PUBLIC COMMENT FORM

Fairview Road & Chapel Hill Road Intersection Improvements

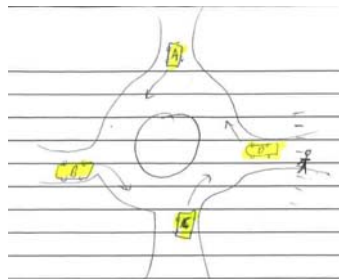
I think roundabouts are good for traffic flow and safety of driving, but I am concerned about the safety of pedestrians. I was informed that it is supposed to be safer for pedestrians too but I have a hard time understanding that. I have two young kids and we often walk to school, and I am concerned for their safety. If the roundabout gets approved, could they add a flashing pedestrian light that can be activated by a button, especially if there is not a large amount of pedestrian crossing? I don't think it would disrupt traffic flow too much.

As a pedestrian, I wouldn't worry about cars "B", "C" or "D" in diagram above as they'd likely see me or still be moving slow enough, but I worry about getting hit by car "A" as they wouldn't see me until they "come around the bend" if he'd built up more speed. But if you put a flashing pedestrian light, it might help. Please consider. Thank you.
